George Zimmerman, CME Consulting, Inc.

Support for Late comment on 802.3cj D2.0, Subclause 98.5.5

Figure 98-8, Section 7, Page 227, Line 8.

Figure 73–9—Transmit state diagram

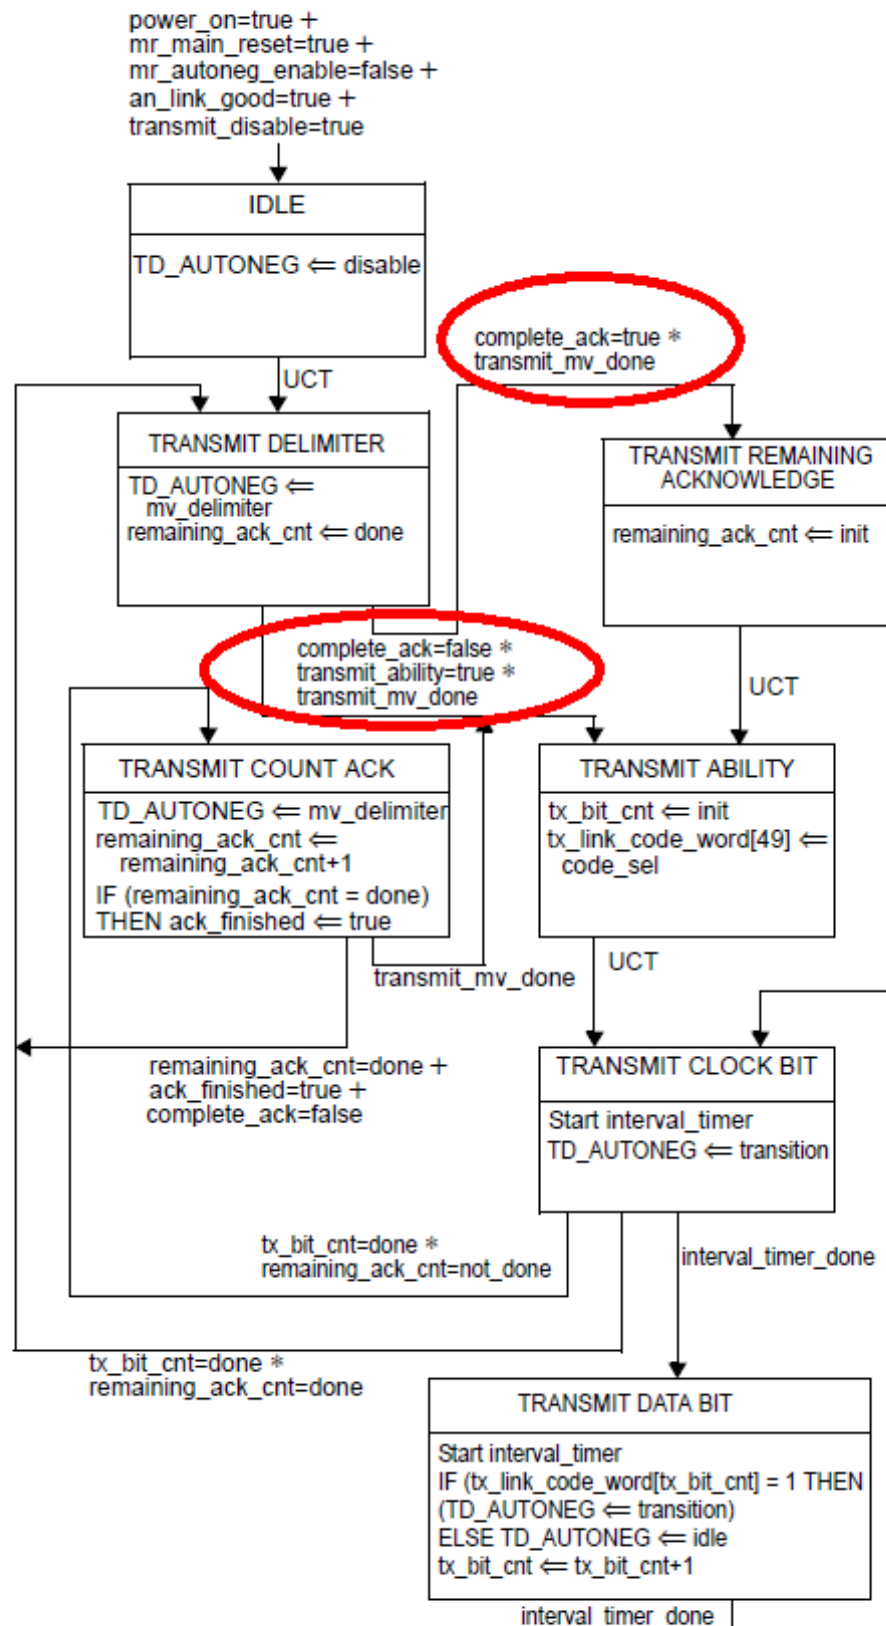
Clause 98 is based on Clause 73. There are some important differences but figure 73-9 shows the expected behavior for the state transitions that are common between them.

Marked up versions of Figures 73-9 and 98-8 follow, showing differences in what is similar logic between the two figures in red circles. OR's in the red circled transition logic of Figure 98-8 should be AND's.

Figure 98-8—Transmit state diagram

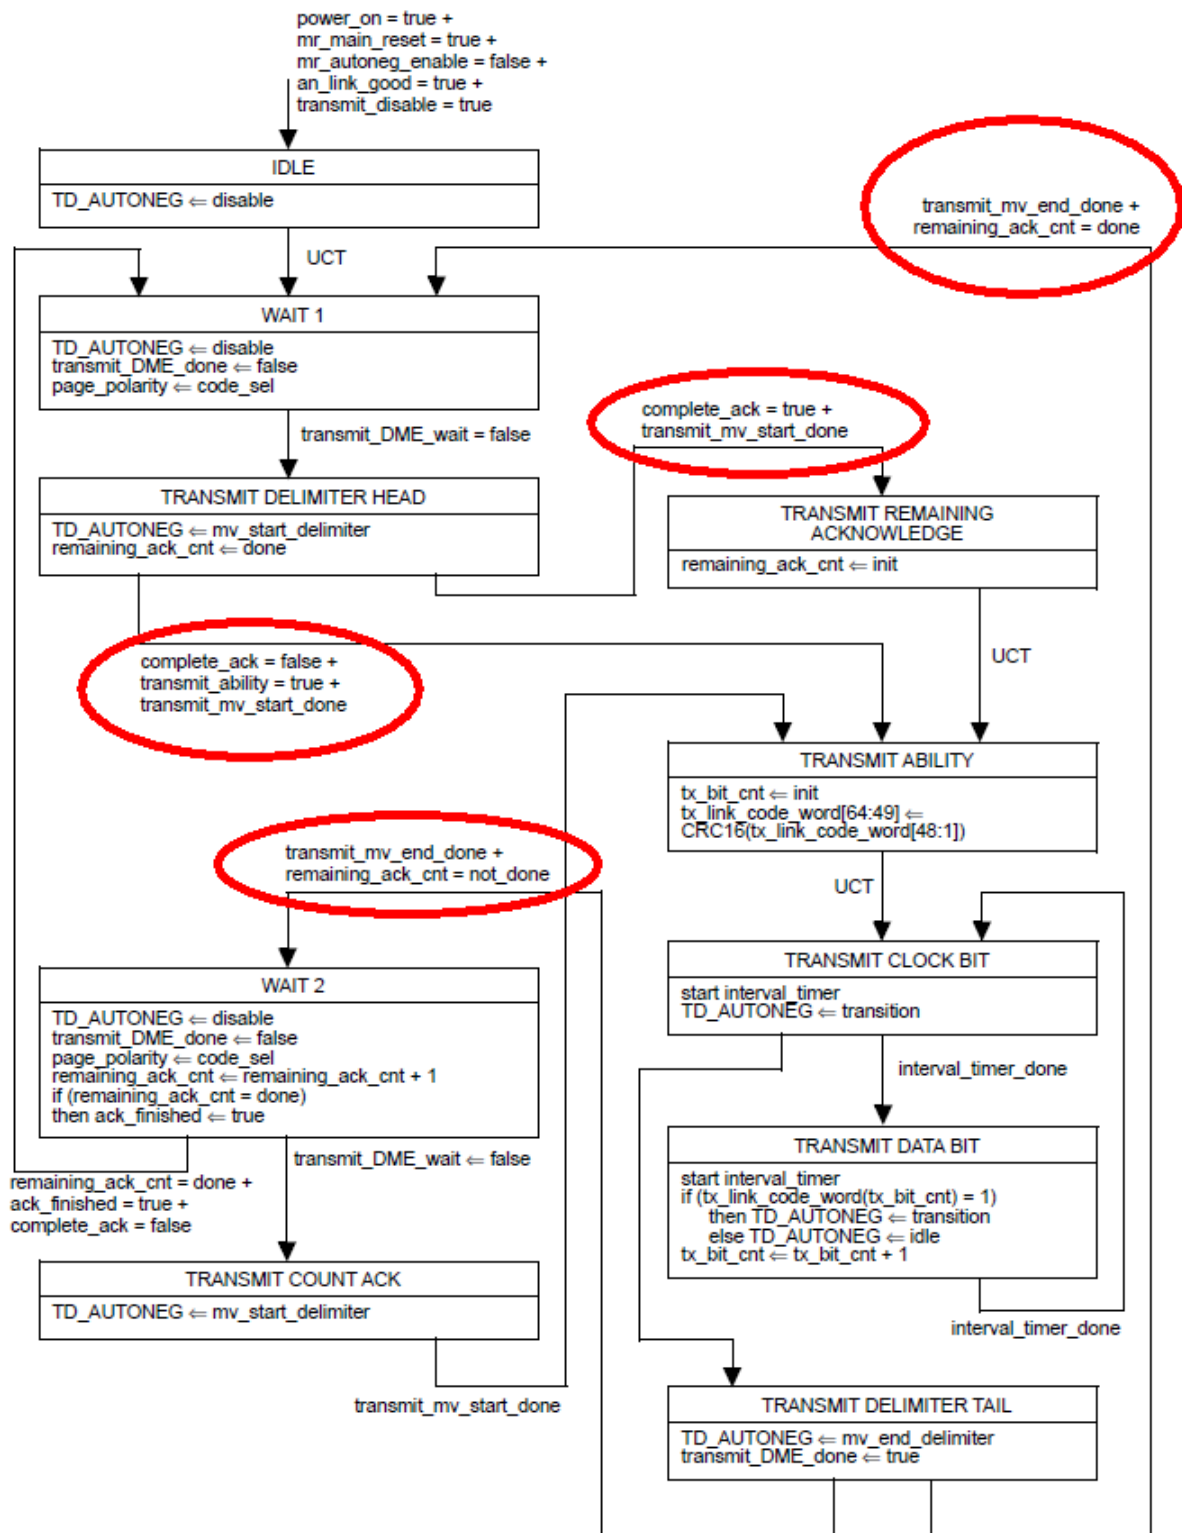
Figure 98-8 has several typos. On 4 transitions (5 places) an OR (+) is indicated for state transitions when the condition should be an AND (\*) - line 8, 14,21 (&22) and line 28. Clause 98 is based on Clause 73. There are some important differences but Figure 73-9 shows the expected behavior for the state transitions that are common between them. (see figures attached as zimmerman\_3cj\_01\_0817.pdf showing Figures 73-9 and 98-8). On 4 transition branches, "\*" (AND) operators, appear to have been replaced with "+" (OR) operators.

Line 8: Change "transmit\_mv\_end\_done + remaining\_ack\_cnt = done" to "transmit\_mv\_end\_done \* remaining\_ack\_cnt = done" on transition from TRANSMIT DELIMITER TAIL to WAIT 1)

Line 14: Change "complete\_ack = true + transmit\_mv\_start\_done" to "complete\_ack = true \* transmit\_mv\_start\_done" on transition from TRANSMIT DELIMITER HEAD to TRANSMIT REMAINING ACKNOWLEDGE

Lines 22 & 23 (2 instances): Change "complete\_ack = false + transmit\_ability = true + transmit\_mv\_start\_done" to "complete\_ack = false \* transmit\_ability = true \* transmit\_mv\_start\_done" on transition from TRANSMIT DELIMITER HEAD to TRANSMIT ABILITY

Line 27: Change "transmit\_mv\_end\_done + remaining\_ack\_cnt = not\_done" to "transmit\_mv\_end\_done \* remaining\_ack\_cnt = not\_done" on transition from TRANSMIT DELIMITER TAIL to WAIT 2.
